CITY OF OPELIKA
HISTORIC PRESERVATION COMMISSION
February 13, 2025
4:30 p.m.
Meeting Chambers at Opelika Municipal Courtroom
300 MLK Boulevard

City of Opelika
Historic Preservation Commission
Staff Report

Agenda Item #: 1
Meeting Date: 02/13/2025
Action Requested: COA: Renew Residential New Construction COA
Location of Property: 515 S. 8th St; Geneva Historic District
Petitioner: Cody Holly

Agenda Item #: 2
Meeting Date: 02/13/2025
Action Requested: COA: Add Dormer
Location of Property: 1013 3rd Ave; Northside Historic District
Petitioner: Compass Construction

Original renderings presented:

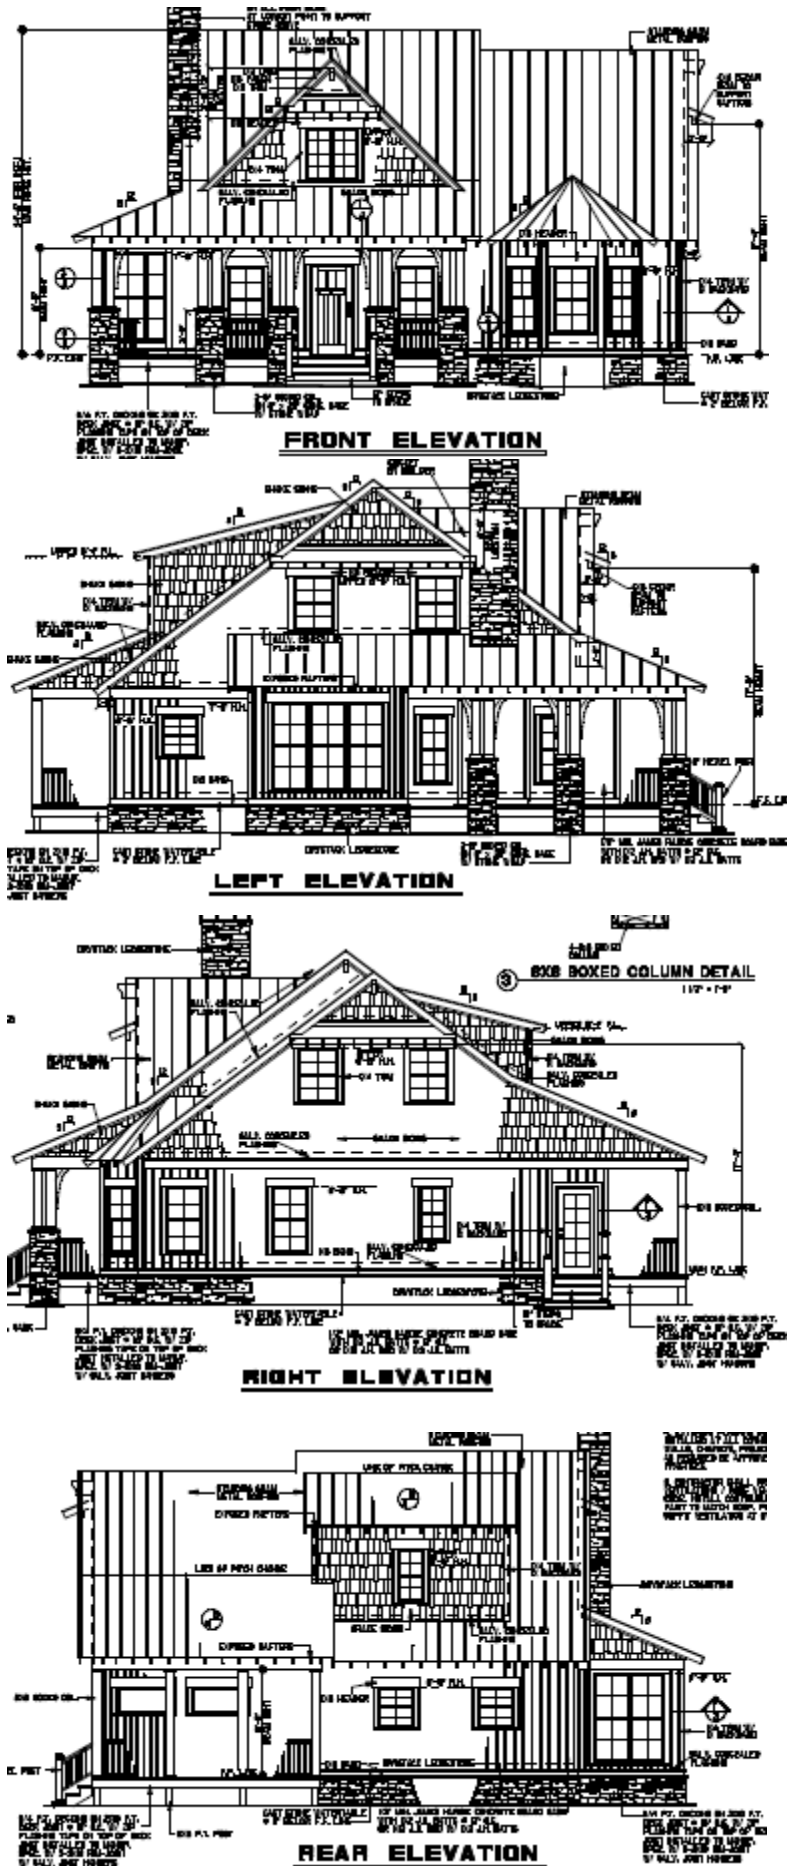
shingle shake will be vertical siding -

New renderings provided: House

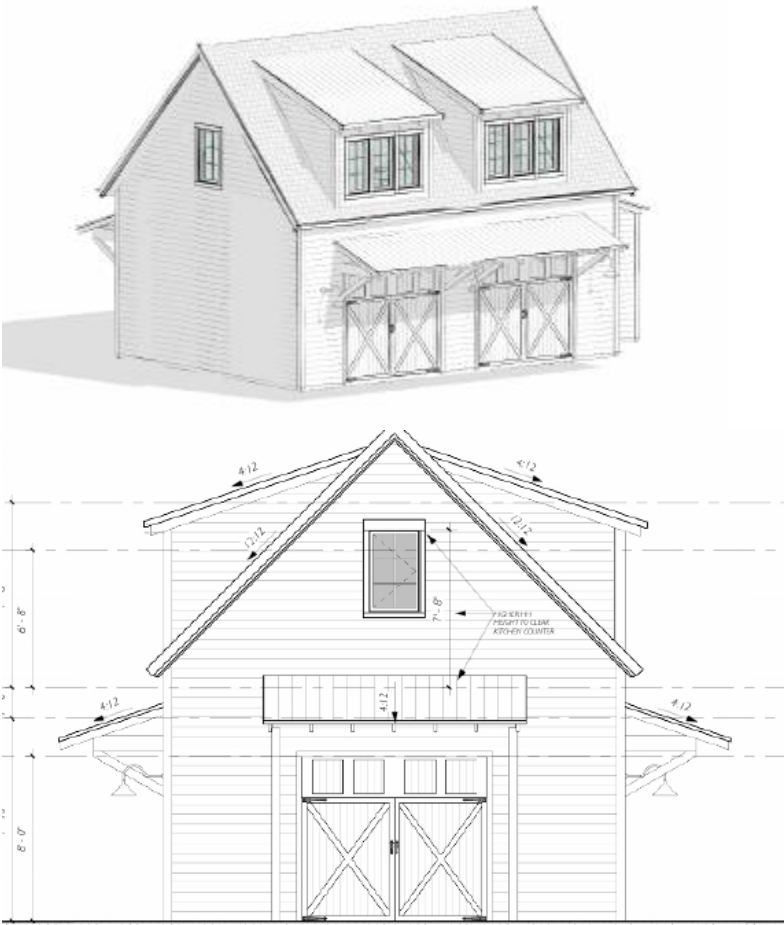
Renderings appear to be the same as previously submitted photos

1. New construction should be compatible with other architectural styles in the district but reflect the era of its own construction. This plan meets the new construction guidelines for height, scale, materials, orientation, and setback.
2. Staff recommends approval of horizontal lap siding and exposed rafter tails, architectural shingle roof, wood columns and porch railings, brick skirting and chimney, painted fiberglass doors, metal garage doors, exterior lighting, and decorative gable accent.
3. Staff recommends approval of casement aluminum window with center break and exterior grids.

Rendering showing proposed front view of new dormer

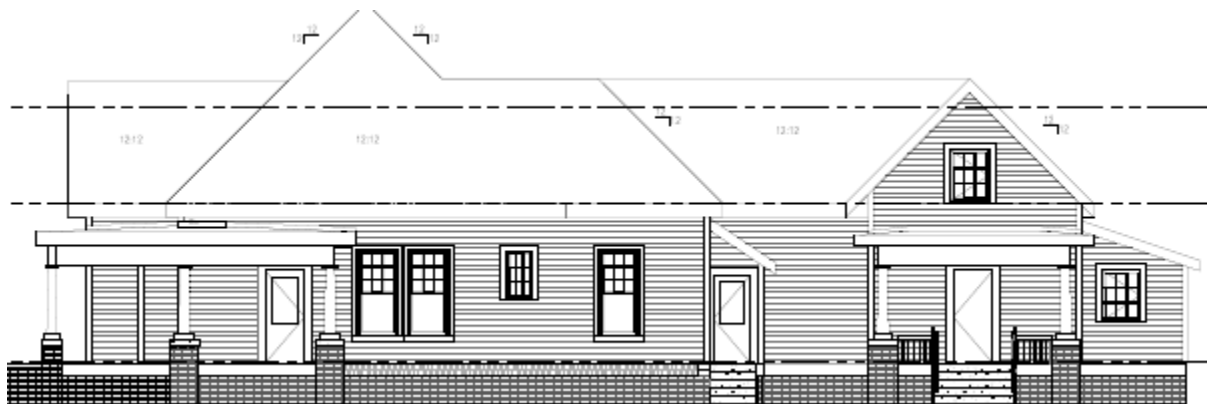
1. Build out attic space adding a new dormer facing 11th St with four windows. Windows are Lincoln aluminum clad 7/8" SDL with internal grids. Exterior siding and trim for dormer will be Hardie and match existing wood siding.

1. Staff recommends approval of side dormer with Hardie siding and trim. All siding and trim to match existing in reveal and width.
2. Staff recommends approval of Lincoln casement aluminum clad windows with 6/6 external grid pattern to match existing windows. Window shall have the look of a double hung window with the same width top rail in center. The casement window is needed to meet the egress requirements per code.
